**Trima Accel® Automated Blood Collection System**

**Trima-032**  
**Version 7.0.4 Software Release**

This service message announces the release of Trima V7.0.4 software and the associated spare parts.

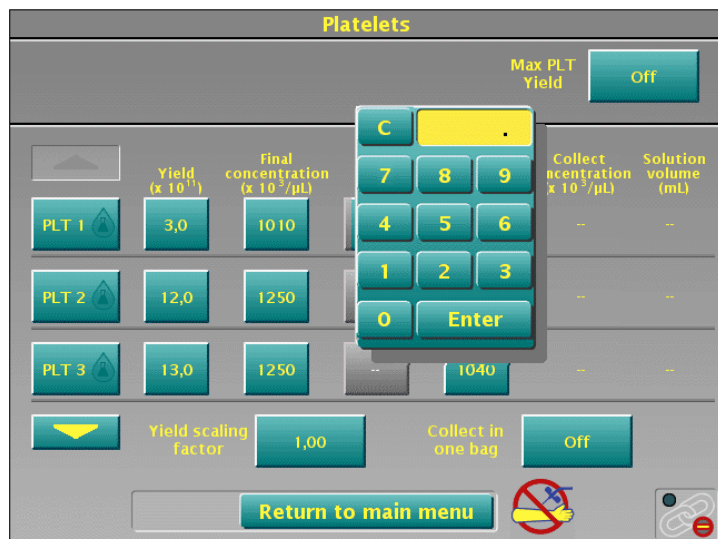
- The GUI state transition issue has been resolved.
  - This will eliminate device failures when scanning multiple barcodes on a single instance of the classic barcode screen.

- 106 Alarm: this alarm caused the run to end while the user is at CFR11 screen. This has been resolved.
- In V7.0.4, Trima network communications are configured to full duplex, and VxWorks is updated to 6.9.4.12. This reduces communication errors when connected to customer networks.

- The Unique Device Identification (UDI) was added to the main screen for operator ease of access when submitting complaints where it is required.
  - Refer to the attached screen comparison.

- Level Sensor Error (144) was triggered during a plasma collection, and the alarm screen was not clear as to why the alarm occurred. Alarm 144 has been replaced with alarm 172 for clarity.

- STS now correctly displays upgrade and downgrade to reflect the change path. This issue has been resolved except for Upgrade/Downgrade path 7.0.3.1 to 7.0.4 due to a software branch issue.

- Alarm 1066 for Setconfig.dat occurring on Trima V7 connected to Vista was resolved by updating the setconfig.dat file in V7.0.4.
